ADDENDUM

TO THE DRAFT COVE PALISADES STATE PARK MASTER PLAN

February 15, 2002

Crooked River
Group Camp Concept w/
Maintenance/Staff
Lodging Alternative
CONCEPTUAL DESIGN
The Cove Palisades State Park
MASTER PLAN
 T125/R12E/S11
 Concept 4.

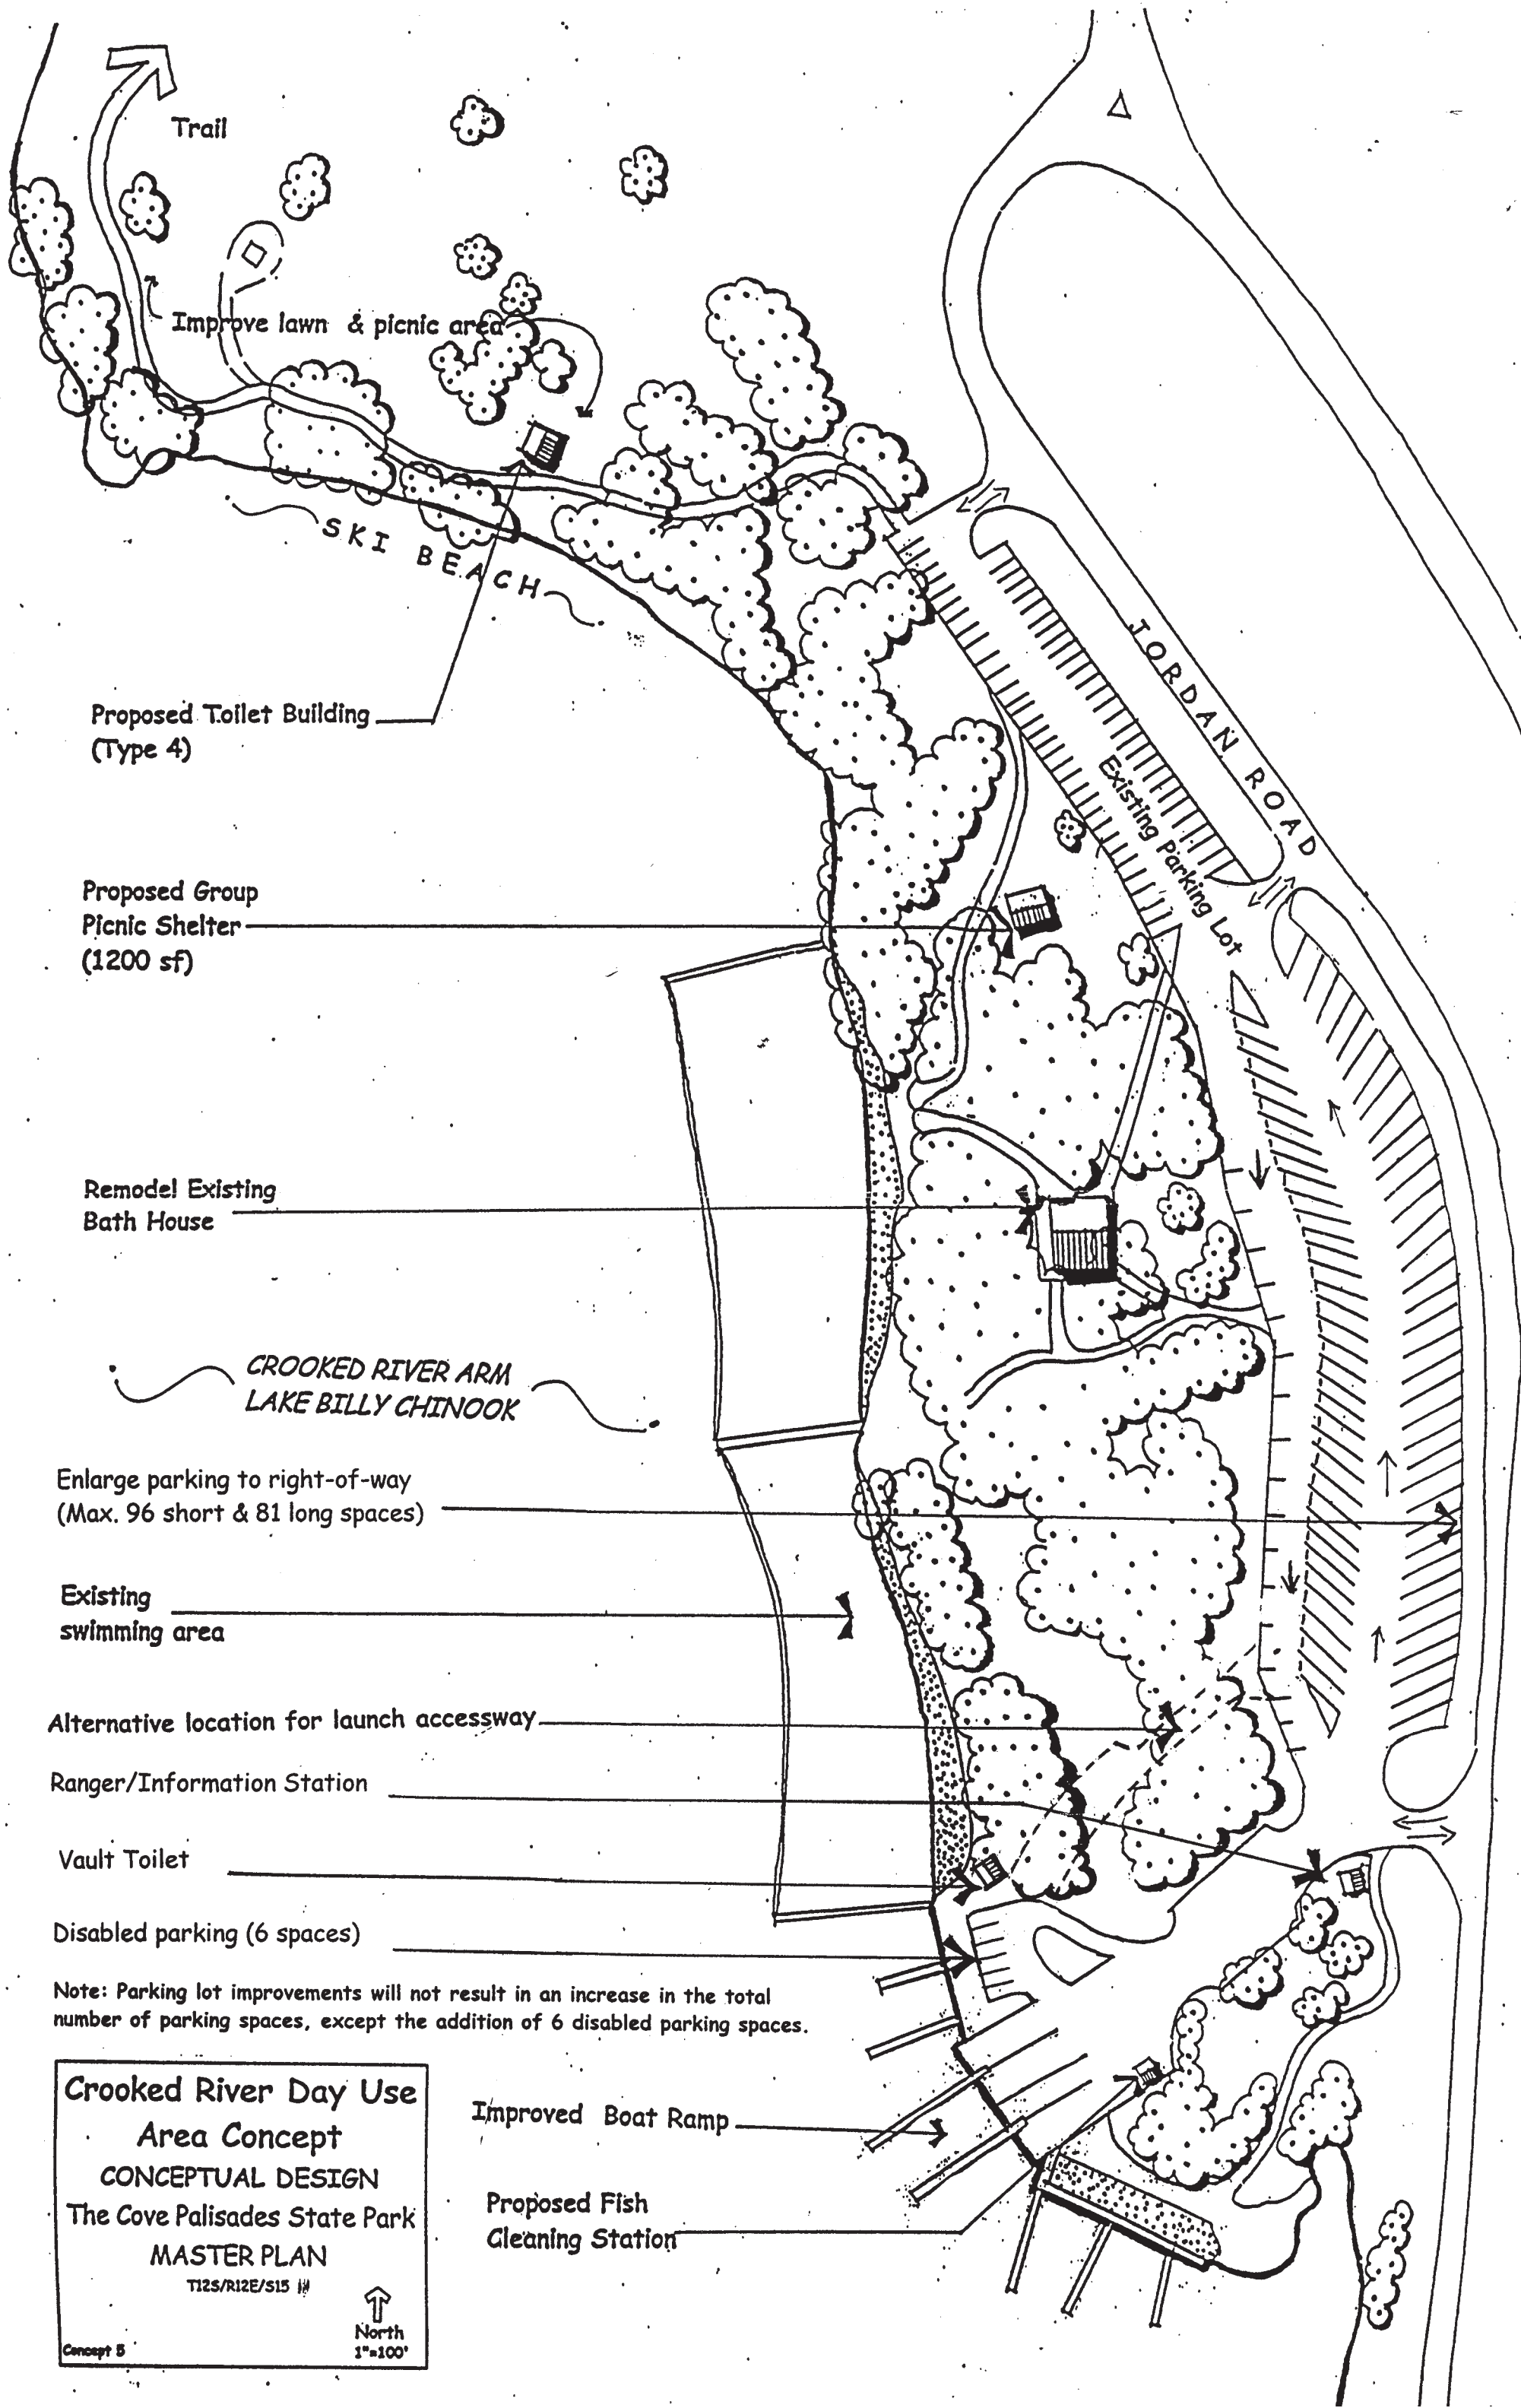
Page 83, replace the “Concept 4” drawing with the updated “Concept 4” drawing attached at the end of this addendum.
